Notification to all users of Mining Controls Inc. MSHA Approved Area Lights

The Model 7015-27434 Area Light with screw-in compact fluorescent lamps has been discontinued

The Model 7015-35777 Area Light with a 4 Pin plug-in type PL-T lamp will be the replacement

LWR LP UPGRADE 6-24-2009

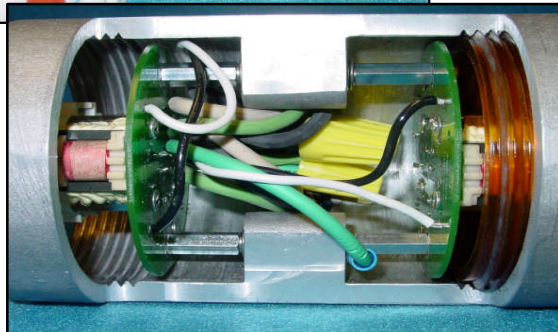
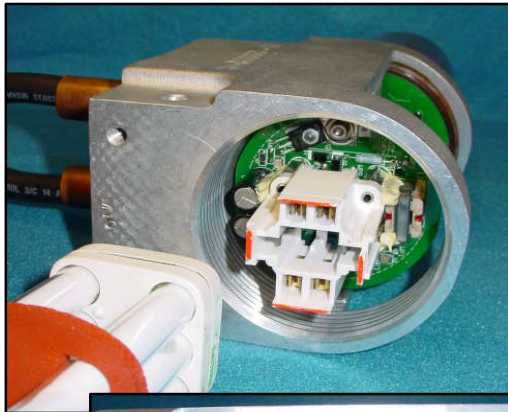
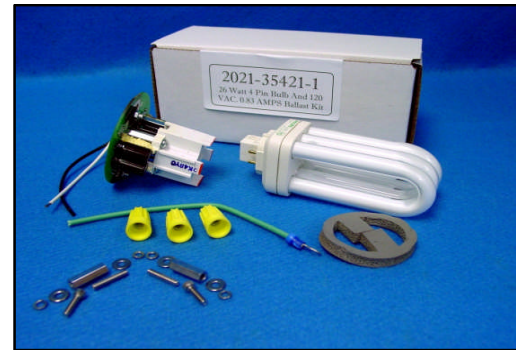
The reason for the change :

- The quality of the screw-in lamp no longer meets the Mining Controls standards for long life
- The new ballast and lamp arrangement for the Model 7015-35777 will insure a longer lamp life
- The new lamp replacement cost is one half of the current lamp
- The new ballast will live twice as long as the current units and will not need to be replaced with every lamp

The current Model 7015-27434 can be upgraded by purchasing the upgrade kit P/N 2021-35421-1
